# Access Compliance Report

## Public Rights-of-Way

Intersection ID: 29206	Main Street: COULOAK_DR	Cross Street: SEASON GROVE_LN	Location: NW
ADA ID: 91248801D1EA	Ramp Type: PerpDiag	Initial Pass/Fail: Fail	Overall Compliance: No
			Severity Score: 48.75

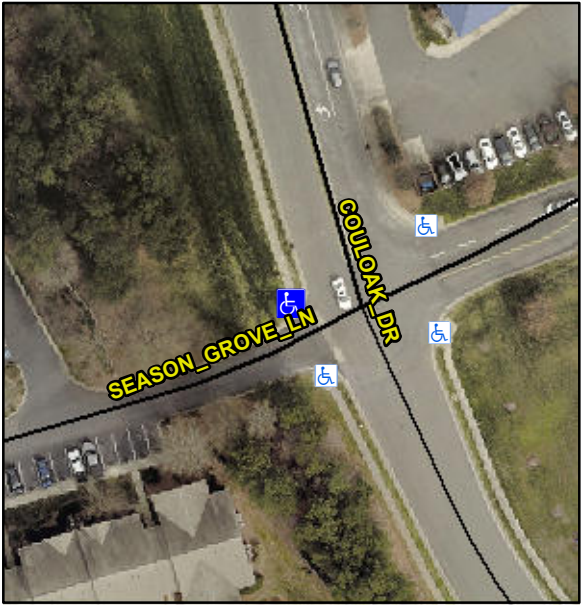
Codes/Mitigation Info/Possible Solution		Field Measurements/Component Compliance			
	Possible Solutions:				
	<b>Remove &amp; Replace Curb Ramp With Two New Directional Ramps or Equivalent.</b>				
	Surveyor Notes:				
	<b>N/A</b>				
	PROW/ADA:				
	<b>Not Found, R304.5.1, R304.2.2, R304.5.3</b>				
	Street 1 Name	SEASON GROVE LN			
	Stop Condition-Street 2	StopSign			
	Street 2 Name	COULOAK DR			
	Stop Condition-Street 1	None			
	Total Cost:	\$ 3200.00			
Compliance	Description	Data	Compliance	Description	Data
N/A	Ramp Length (in)	82.0	No	Ramp Slope (%)	9.5
No	Ramp Width (in)	24.0	No	Ramp XSlope (%)	2.7
N/A	Flare Type LT	N/A	N/A	Flare Type RT	N/A
N/A	Flare Slope LT (%)	N/A	N/A	Flare Slope RT (%)	N/A
N/A	Flare Traversable LT?	N/A	N/A	Flare Traversable RT?	N/A
N/A	Landing Length (in)	N/A	N/A	DWS Provided?	N/A
N/A	Landing Width (in)	N/A	N/A	DWS Contrast?	N/A
N/A	Landing Slope (%)	N/A	N/A	DWS Length (in)	N/A
N/A	Landing X Slope (%)	N/A	N/A	DWS Full Width?	N/A
